## MRP-169 NRC RAI Response NRC Meeting

August 23, 2007

## **NRC RAI Background**

## MRP-169 RAIs – Significant Questions and Responses

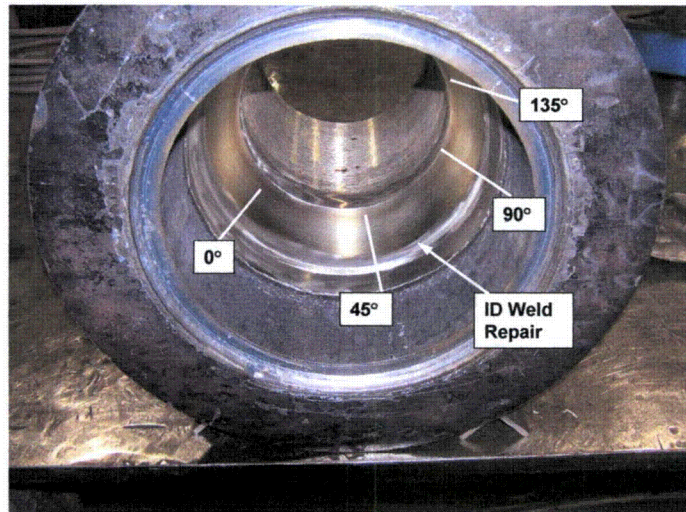
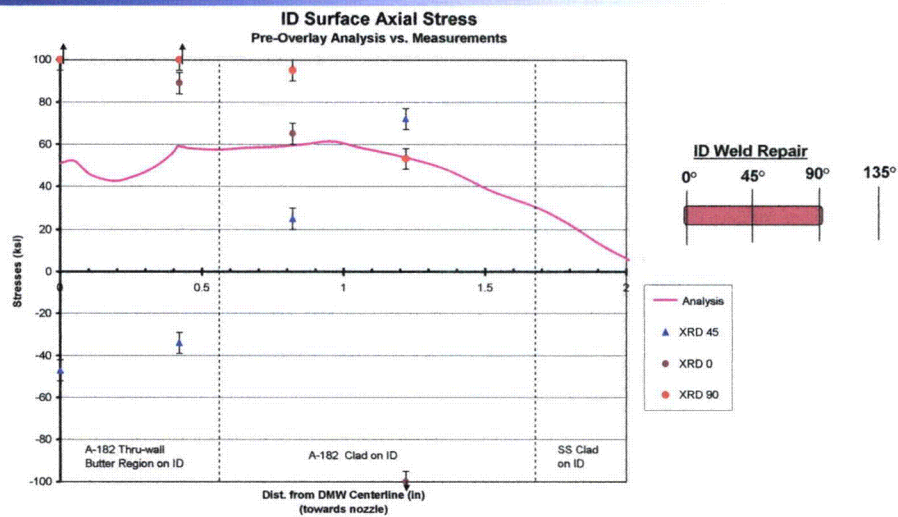
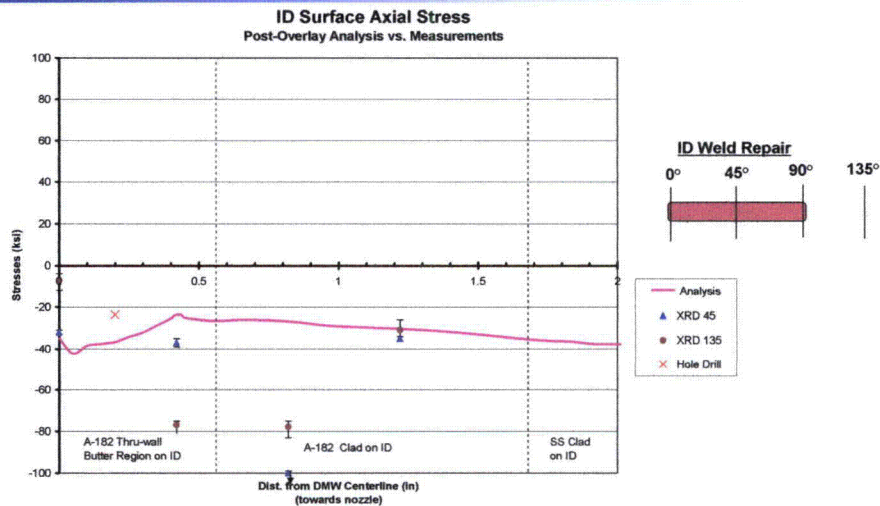
- Stress Analysis #4 – Discuss why stress distributions in mock-up PWOL are different from those in example nozzle PWOLs
- Response –
  - PWOL mockup simulates a surge nozzle. Surge nozzle stress contour plots will be added to revised MRP-169
  - Mockup residual stresses in Section 5 were reported at room temperature for comparison to XRD measurements, surge nozzle example in Section 8 was reported at operating temperature
  - Post-overlay residual stresses for mockup and surge nozzle example do not differ significantly under consistent conditions
  - Detailed stress plots are provided in RAI response that demonstrate this point
